## Memo

**Subject** Moorebank Intermodal Site Stormwater and Flood Conditions November 2017  
**Author** Richard McManus and Mark Wainwright  
**Distribution** Department of Planning  
**Date** 16 November 2017

We have undertaken a review of Stormwater Quantity and Quality documents associated with the MPE and MPW sites. The review is presented in the following sections:

Figure 4-3 MPE pre-development sub-catchment plan (Arcadis, 2016b)

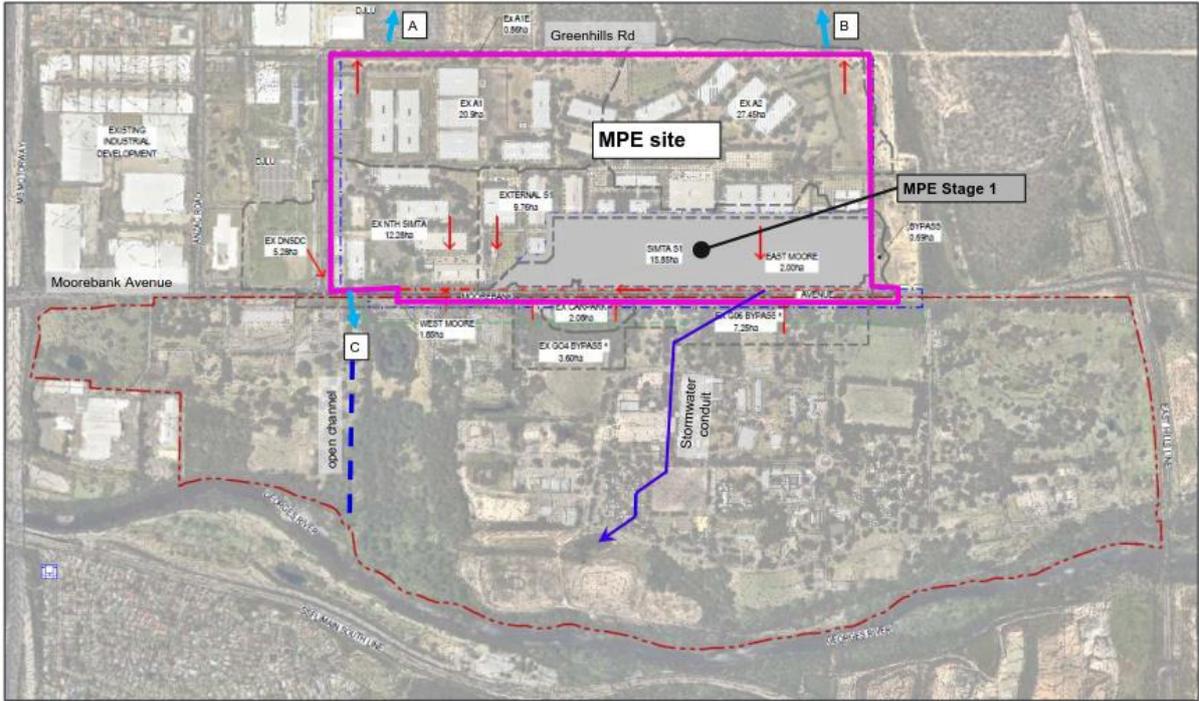
1. Updated catchment plans for the pre-development and post development conditions should be provided by the applicant for the MPW and MPE sites. These catchment plans should clearly show labelled site contours at an appropriate interval to enable the defined sub-catchments to be confirmed.

Pre-development sub-catchments	<p>Drainage sub-catchments for the MPW site primarily comprise land to the west of Moorebank Avenue draining to the Georges River. A low north-south ridge through the adjacent MPE site directs runoff from the western portion of this site (approximately 50% of the site) in a westerly direction towards Moorebank Avenue. Moorebank Avenue grades in a northerly direction conveying runoff from the eastern side of Moorebank Avenue to an existing concrete lined open channel through the MPW site. An additional piped stormwater drainage line collects stormwater from</p>	<p>The eastern portion of the MPE site drains to Anzac Creek. The western portion of the MPE site drains to an existing channel in the MPW site that discharges to the Georges River.</p>

Figure 4-4 MPE post development sub-catchment plan showing proposed detention basin locations (Arcadis, 2016b)

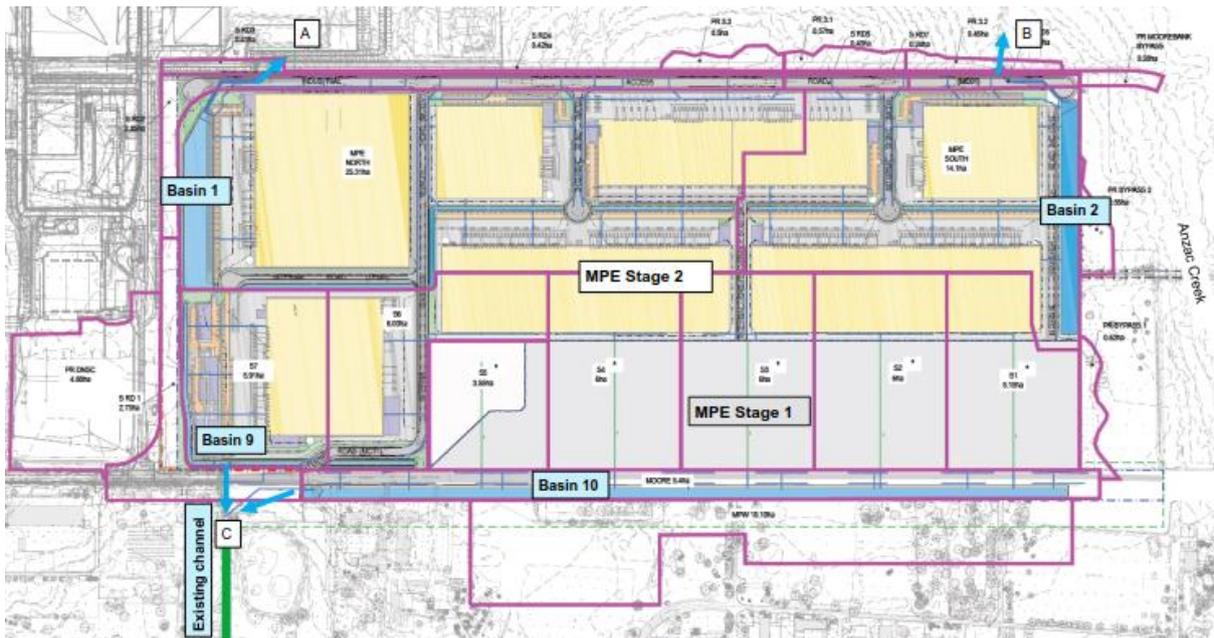
Post-development sub-catchments	<p>The MPW site would be drained to a series of OSD basins (Basins 3a, 4, 5, 6 and 8) to manage flooding hydrology from five separate local catchments. The proposed basin locations are shown on Figure 5-2 in the report.</p> <p>The proposed re-grading of the southern portion of the MPW site would direct an additional 15 ha of land to proposed Basins 6 and 8 that drain to the Georges River, with an equivalent reduction in catchment area draining to Anzac Creek through proposed Basin 3a. With the exception of the southern portion of MPW land, it is our understanding from the provided information that the pre-and post-development catchment areas draining to Anzac Creek and the Georges River will be similar.</p> <p>Comments and recommendations:  <i>Similar to the pre-development sub-catchments, a clear catchment plan showing the proposed finished surface grading was not provided by the applicant for the MPW site. Our comments assume that the post development sub-catchments draining to each basin have been defined appropriately by the applicant.</i></p>	<p>The MPE site sub-catchments would be drained to four OSD basins (Basins 1, 2, 9 and 10) to manage flooding for separate sub-catchments. Basins 1 and 2 drain to Anzac Creek, and Basins 9 and 10 to the Georges River (initially through MPW). The proposed basin locations are shown on Figure 4-8 in the report.</p> <p>The north-eastern portion of MPE drains to proposed Basin 1 prior to discharging across the eastern site boundary through an existing box culvert into a channel in the adjacent DNSDC site. The south-eastern portion of MPE drains to proposed Basin 2 that discharges to the east into an existing minor tributary of Anzac Creek.</p> <p>Basins 9 and 10 would manage runoff from the western portion of the MPE site that currently drains to Moorebank Avenue prior to discharging through a culvert into the existing concrete lined channel located within the MPW site.</p> <p>Comments and recommendations:  <i>Similar comments and recommendations to the post development sub-catchments for the MPW site apply to this site.</i></p>

Figure 5-1: MPE stormwater modelling layout.

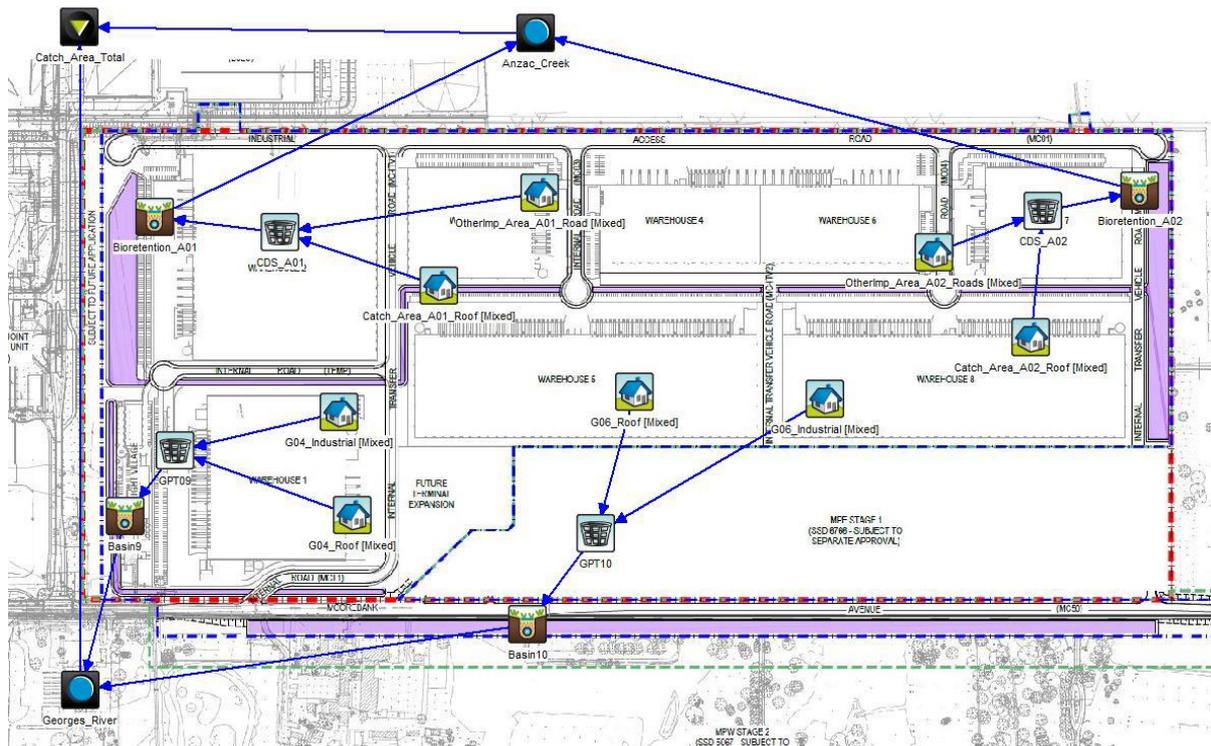
The MUSIC modelling has informed the proposed strategy for MPE as outlined in Table 5-3 and Figure 5-1. The stormwater treatment systems are in the base of the OSD systems. The stormwater treatment systems are between 0.7% and 2.3% of the catchments draining to the locations, with treatment system A01 being three times as large as system A02.

Figure 5-2: Stormwater Basin Typical Detail, showing bioretention system in the base of the Stormwater OSD Basin. Note the depth of water above the bioretention filter media.

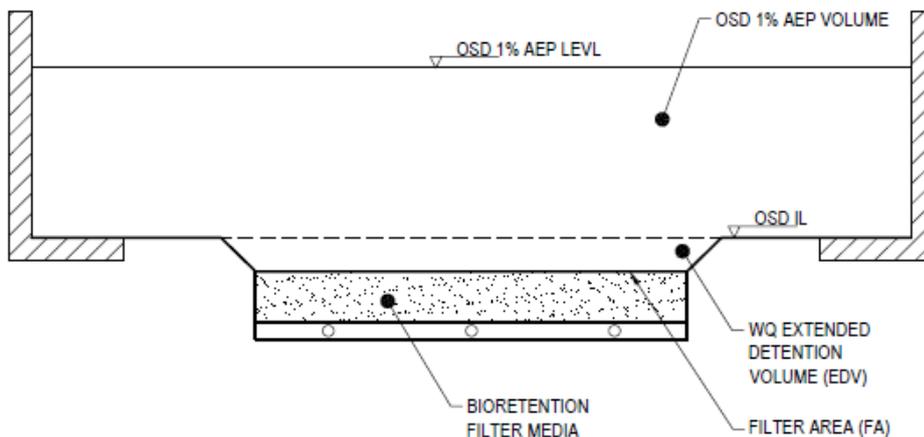
Both the MPE and MPW reports states that “Rain gardens are proposed in the base of the stormwater basins” (Section 6.2). This is further detailed in the drawings, which show a typical stormwater basin in the base of an Onsite Detention system (a cross-section is shown in the following image). This is contrary to the MPW REMMs which require “A stormwater treatment system would be implemented, incorporating sedimentation and bio-filtration basins upstream of the stormwater detention basins” (MPW REMM 9X).

It is not recommended, nor is it good practice, for stormwater treatment systems to be in the base of large OSD systems, due to:
